CLUB DE GOLF LOS LEONES LAS CONDES - SANTIAGO - CHILE

SITE REPORT FOLLOWING VISIT IN JANUARY 2011

A D A M G O L F D E S I G N ARQUITECTOS DE CANCHAS DE GOLF

PROPOSED VIEW FROM THE TEE - HOLE N°6

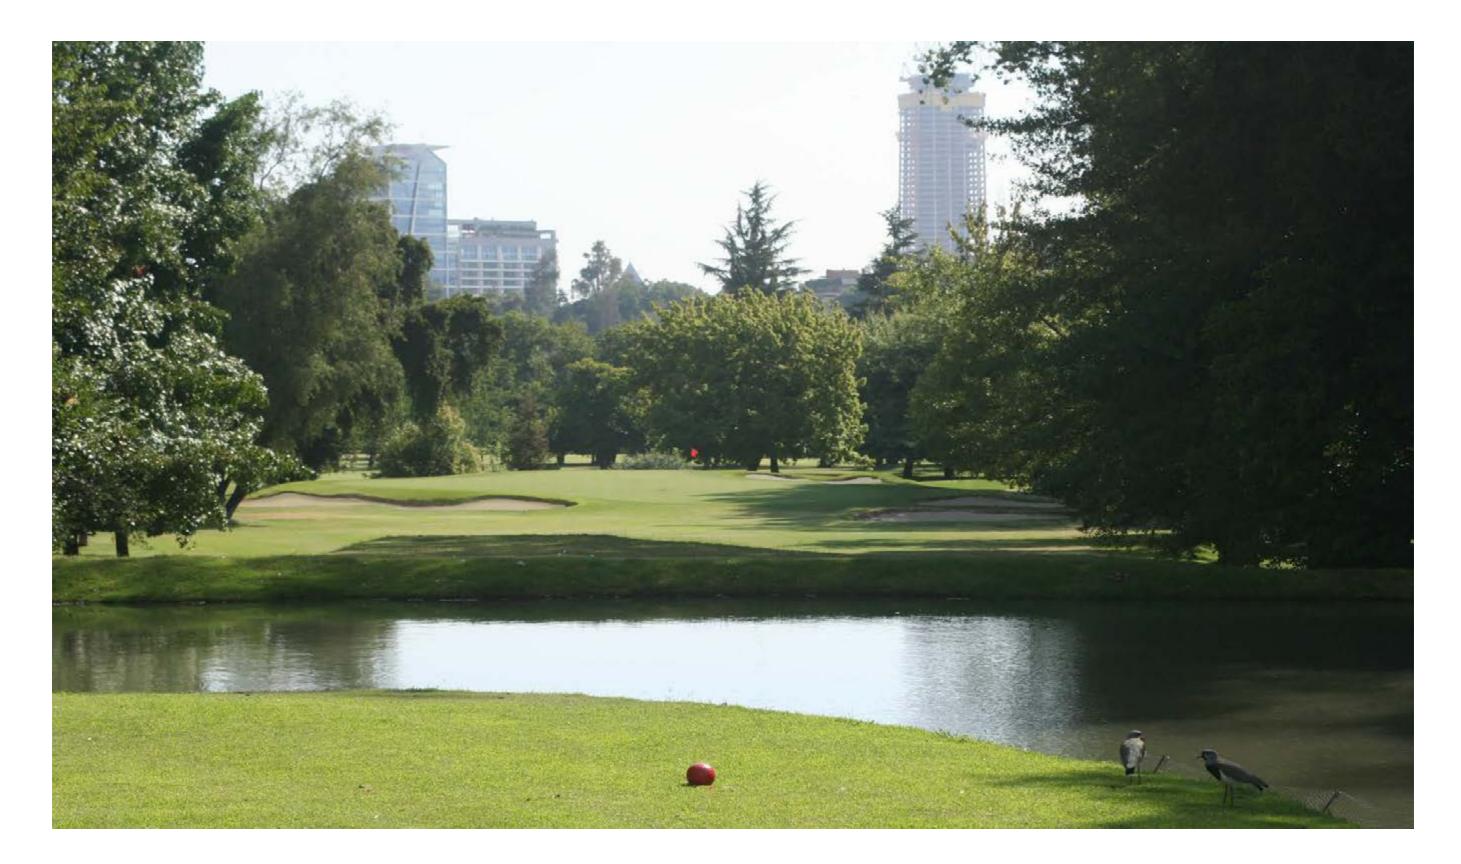
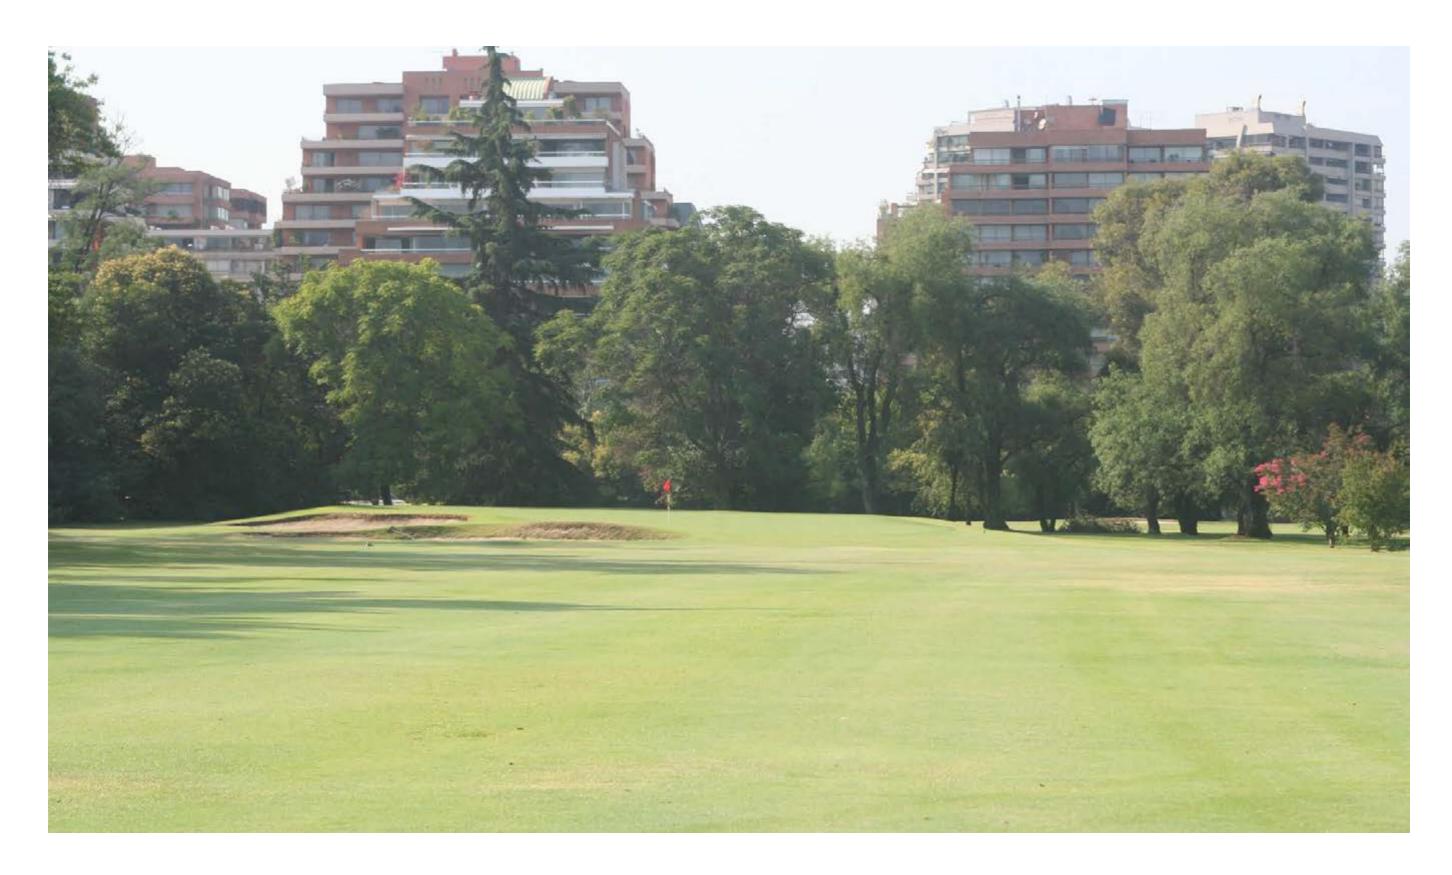
At present the tree branches on the right side just after the lake are partially blocking the view of the two right side bunkers. The back green bunker is barely visible. The lip of the left green bunker needs to be softened for a better visual appearance and to facilitate maintenance.

We propose to remove the branches on the right side just after the lake to have a better view of the two right side bunkers. We also propose to make the back right bunker more visible by making a small mound behind the existing bunker, and having the sand line go up the mound. We also propose to soften the lip of the bunker by filling partially inside the bunker, so as to improve the visual appearance and to facilitate maintenance.

PROPOSED VIEW OF THE GREEN AREA - HOLE N°7

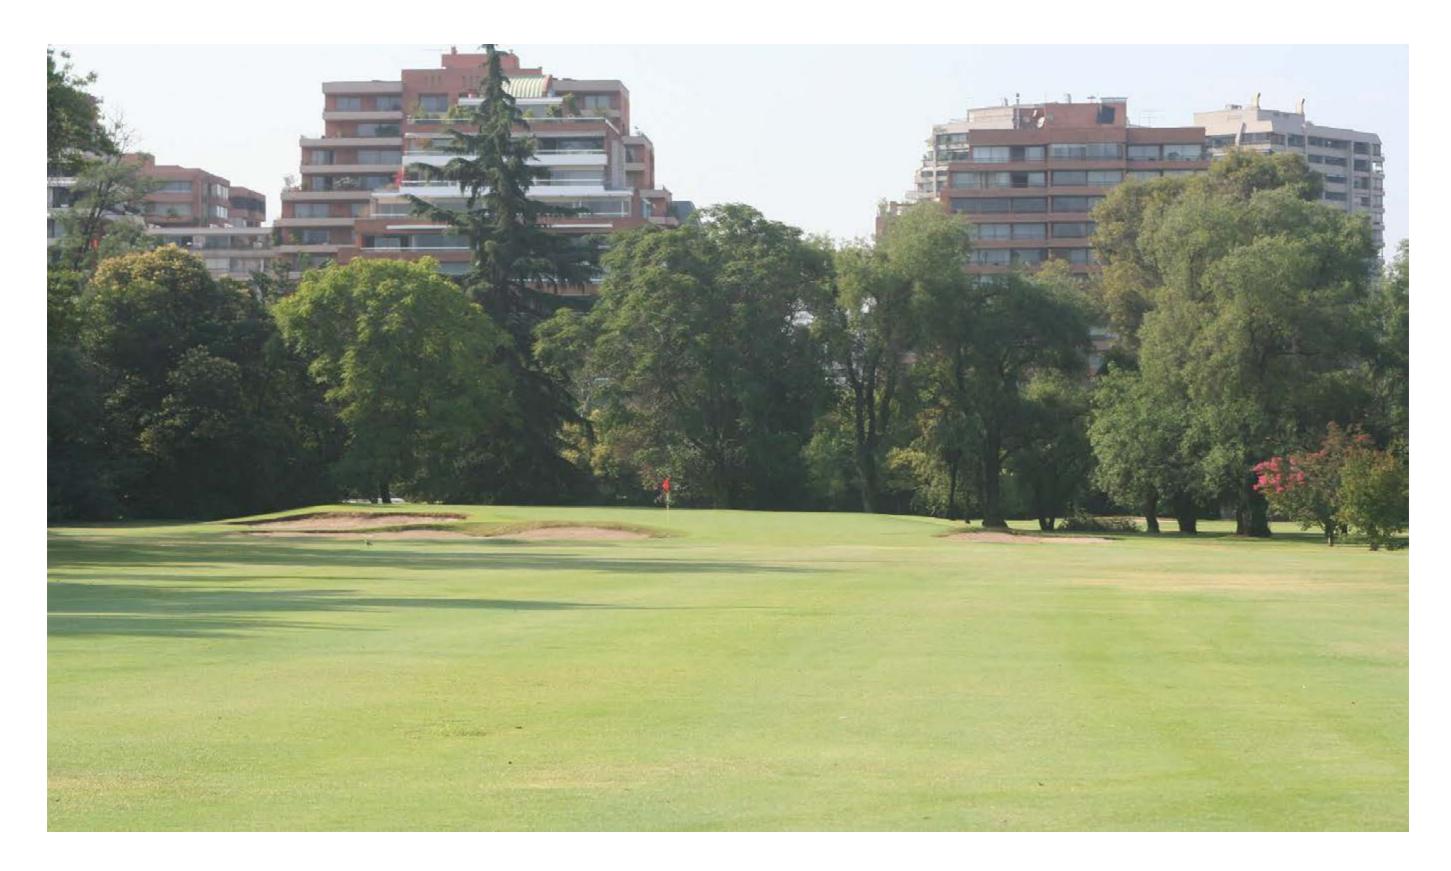
At present the bank of the front green bunker needs to be softened. The right side of the green is totally open.

We propose to soften the bank of the left front green bunker by filling within the bunker and also raising the sand line. This will improve its visual appearance and facilitate maintenance. We also propose to place a bunker on the right at the front of the green to frame the green and to also create more strategic variety and create a more difficult pin area at the front of the green.

EXISTING VIEW FROM BEHIND THE BACK TEE - HOLE N°9

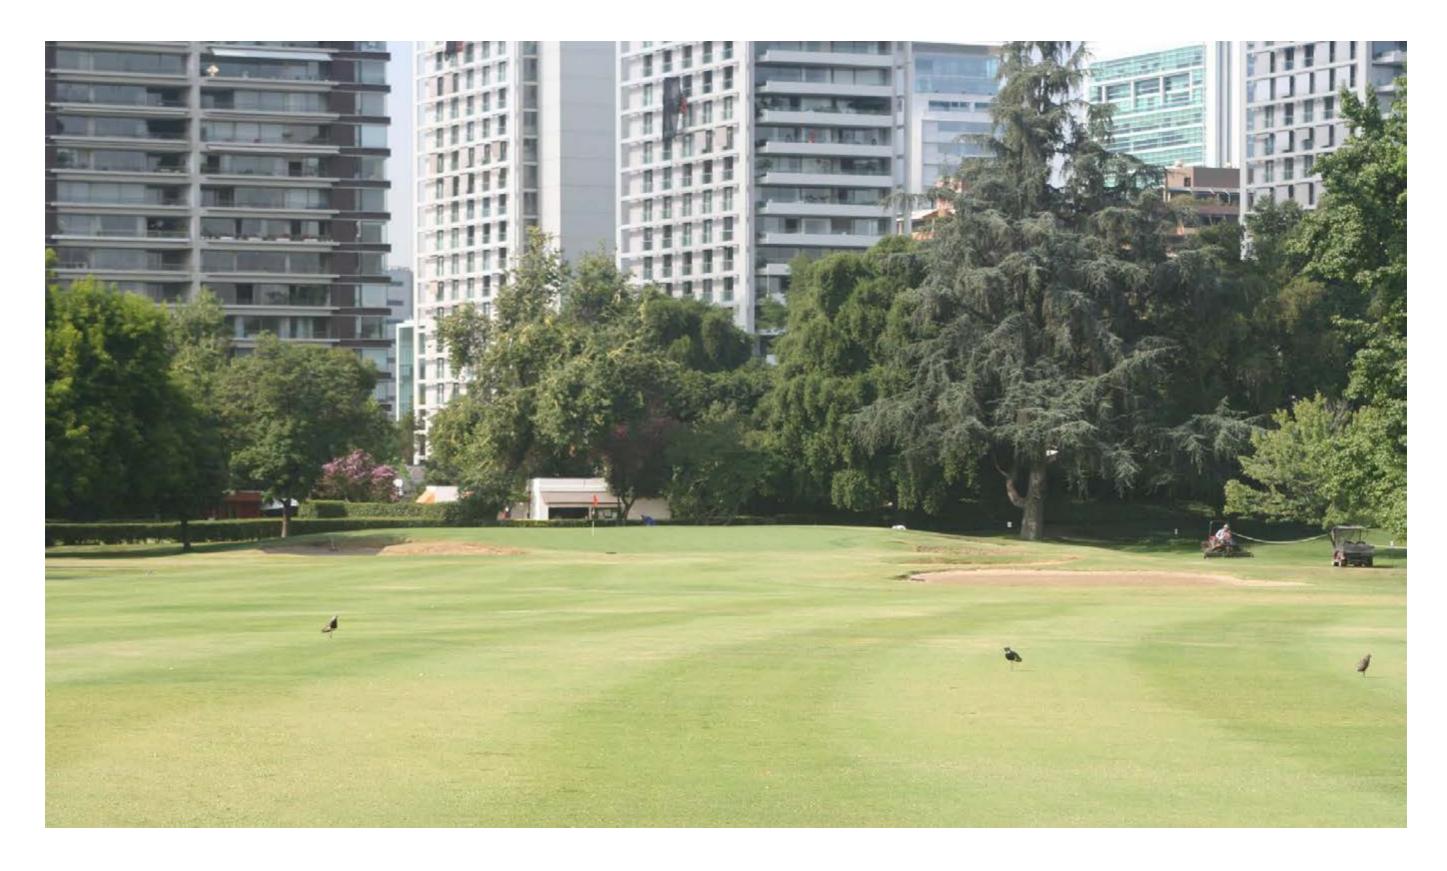
At present from the back tee, some players are cutting the dog-leg, especially during the Copa de Andes tournament.

We propose to extend the back of the tee box 8 metres with the back slope ending at the control box. We also propose to remove some of the branches of the linden tree to do these works.

PROPOSED VIEW FROM THE SECOND LANDING AREA - HOLE N°9

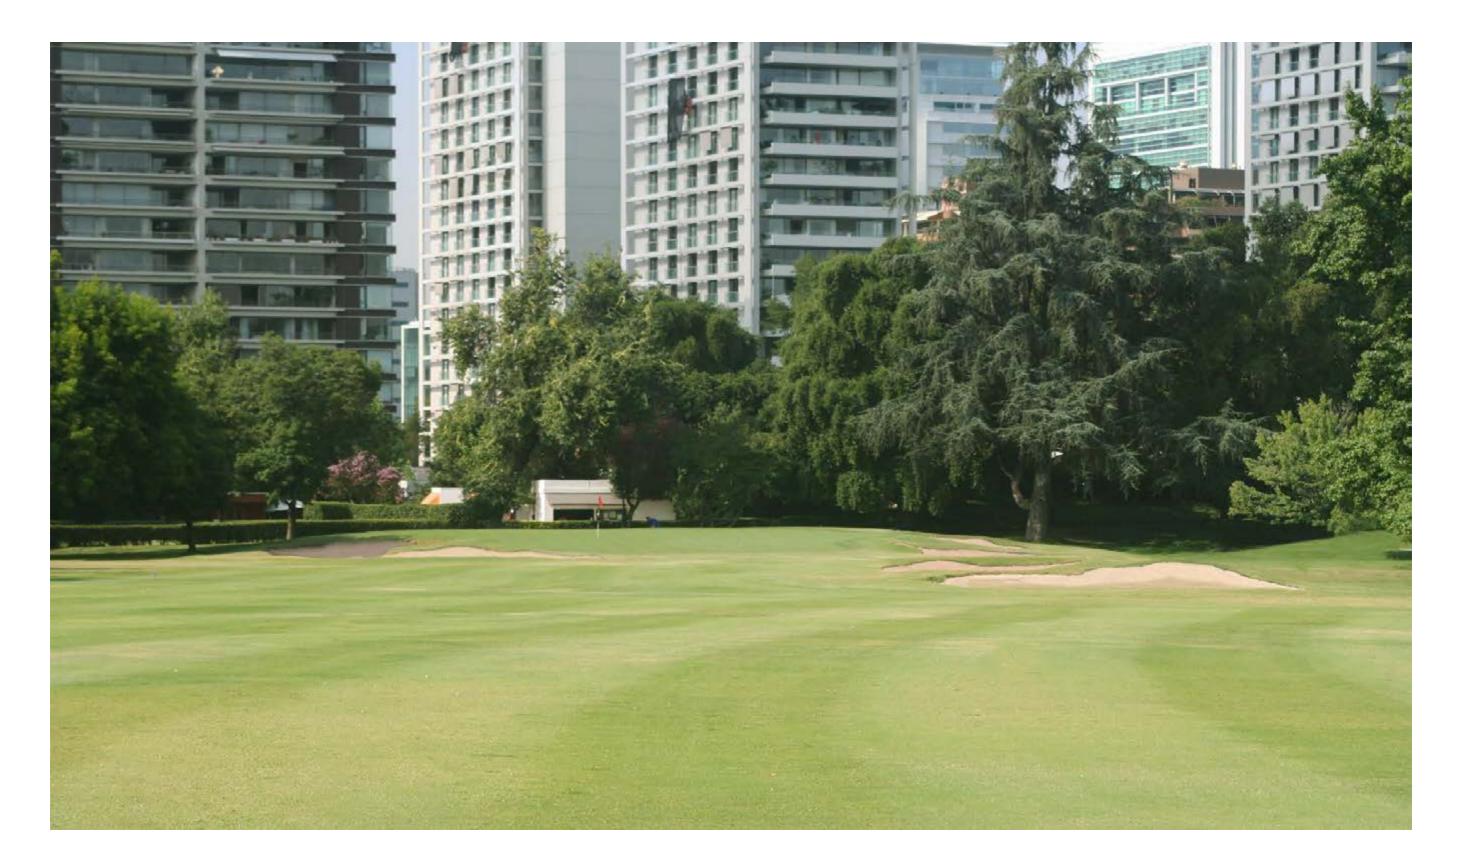
At present the left green bunker is lateral to the green and as such doesn't allow for a more difficult pin position. All the existing green and fairway bunkers need remodelling. The second green bunker on the right needs to be more visible.

We propose to extend the left green bunker so that is more frontal and closes off partially the front of the green. This will also allow for some more difficult pin positions. We also propose to bring the sand line back up the slope of the bunker to make it more visible and visually appealing. We also propose to reduce the size of the first fairway bunker and to raise the lip, but in such a way that the other bunkers behind remain visible. We also propose to raise the sand line in the next fairway bunker, as well as on the first green bunker on the right. We also propose to make some mounding behind the second green bunker on the right, so that the sand line can be raised and the bunker becomes more visible.

EXISTING VIEW OF THE LANDING AREA - HOLE N°10

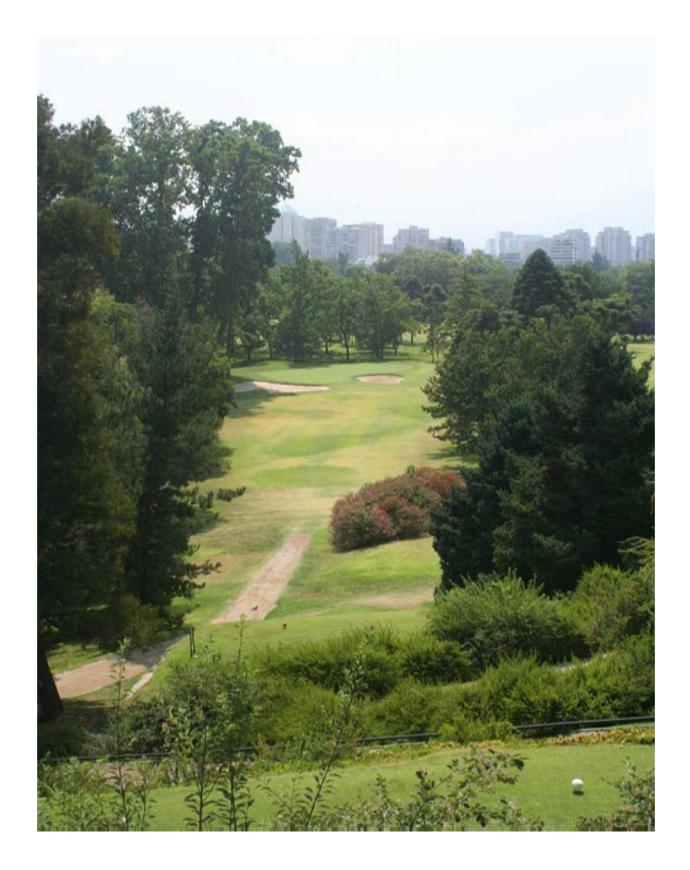
At present this short par 4, poses no challenges and choices off the tee. The bunkers on the right could be made more visible.

We propose to place a bunker at the turn of the hole on the left hand side of the fairway. This will bring some strategic interest to the hole and make the cutting of the dog-leg much more hazardous. It will also give greater composition to the hole. We also propose to raise the left fairway bunkers to make them more visible.

PROPOSED VIEW FROM THE TEE - HOLE N°11

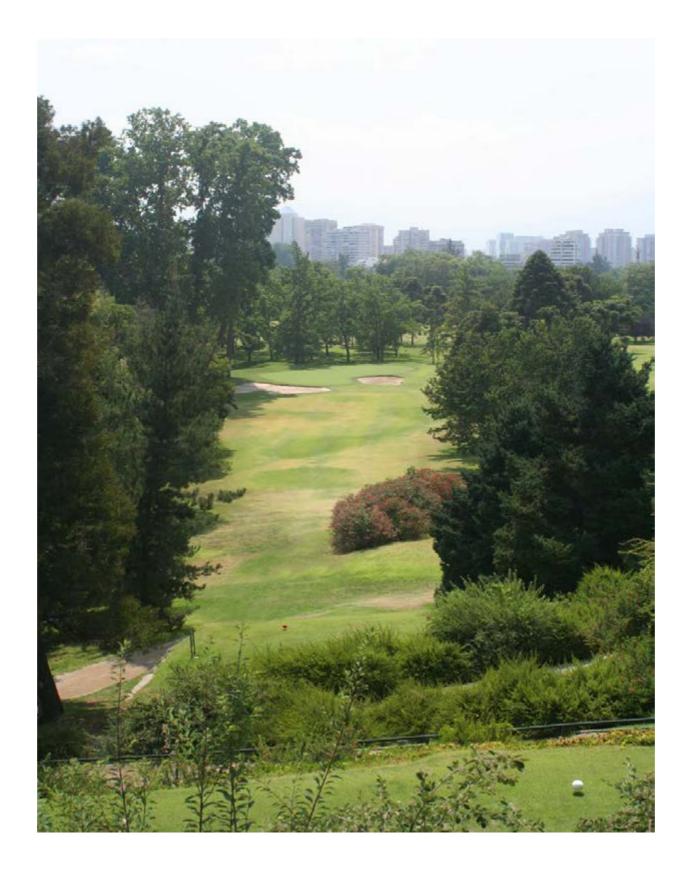
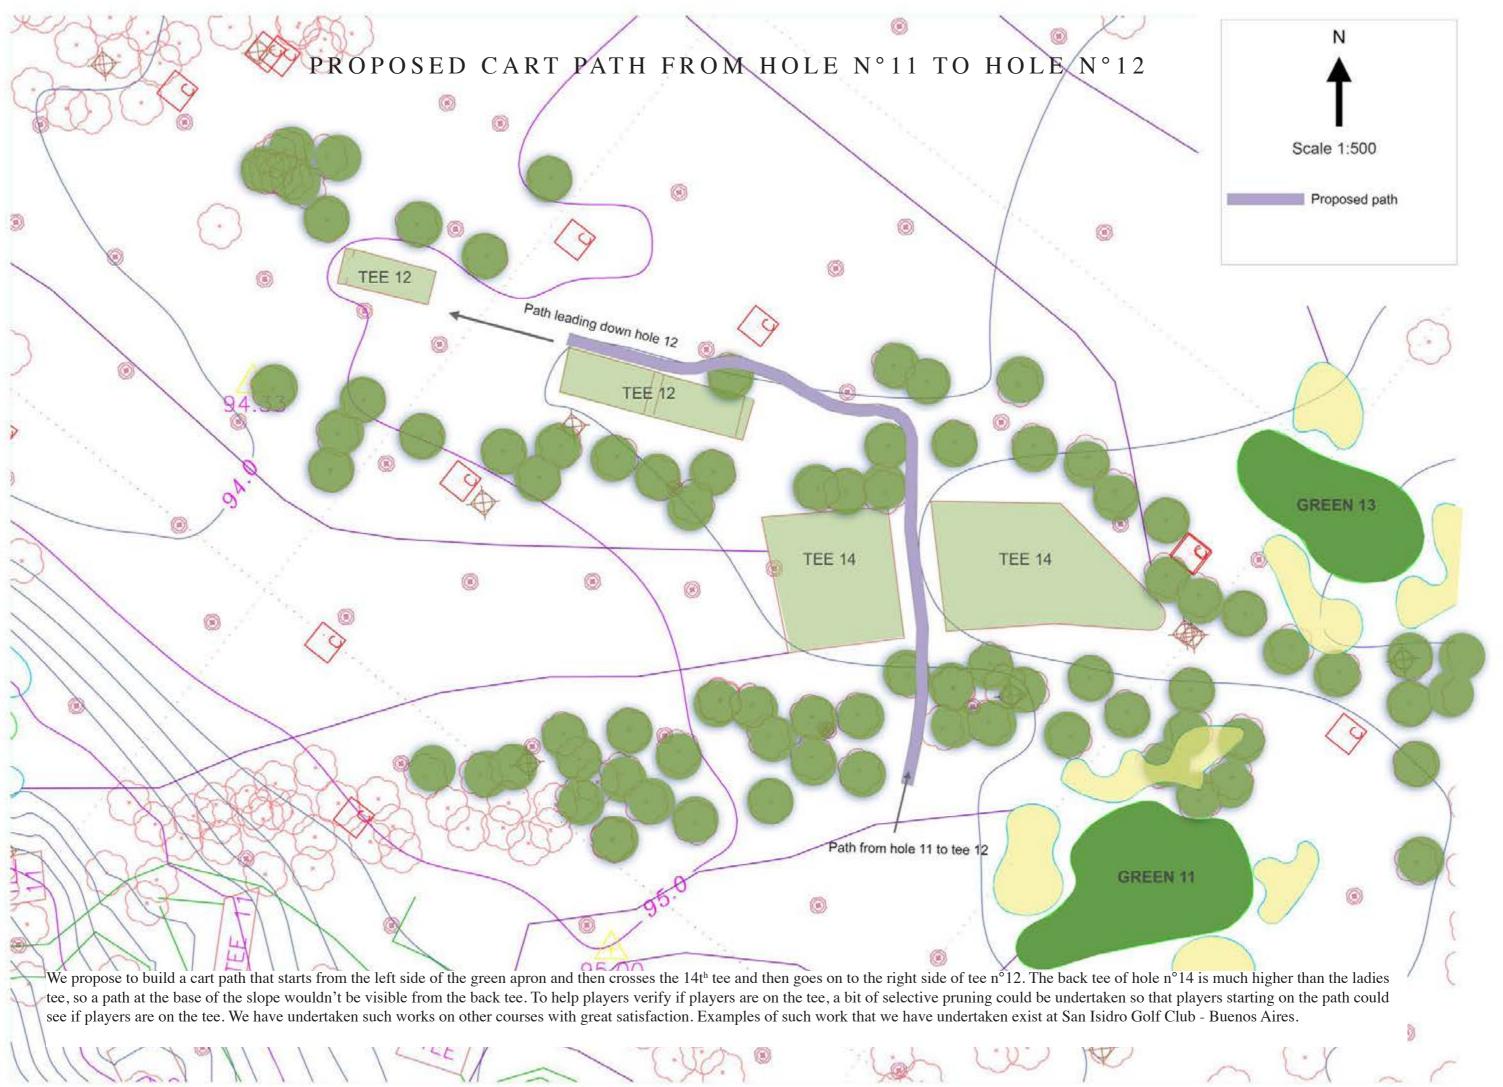
At present the cart path is spoiling this very picturesque hole. The pine tree on the left is blocking the view of the left side of the green bunkers from the tee.

We propose to remove the cart path and have the players go round the red bush. We also propose to remove the pine tree on the left side at the level of the fairway that is obstructing the view of the green bunkers on the left side.

EXISTING VIEW FROM THE TEE - HOLE N°15

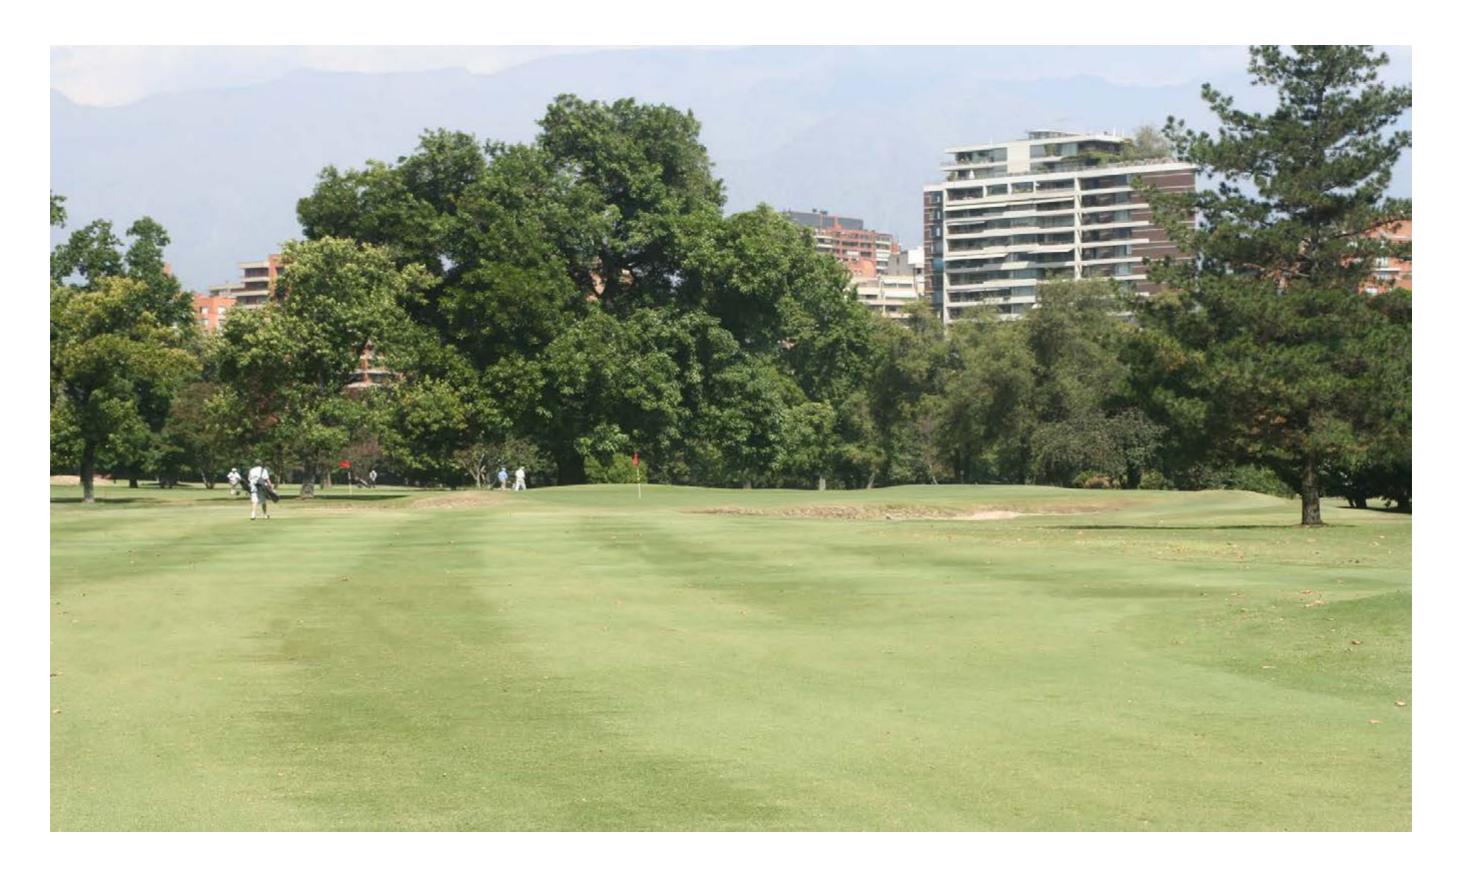
At present from the tee one cannot see the 2nd fairway bunker on the right. The left fairway bunker is visually a straight line and not very visible. From the beginning of the fairway, no fairway bunkers are visible.

We propose to add some mounding behind the left fairway bunker, to help raise the sand line and to help give visually a more curvilinear line on the horizon. We also propose to cut the branches that are blocking the view of the two fairway bunkers.
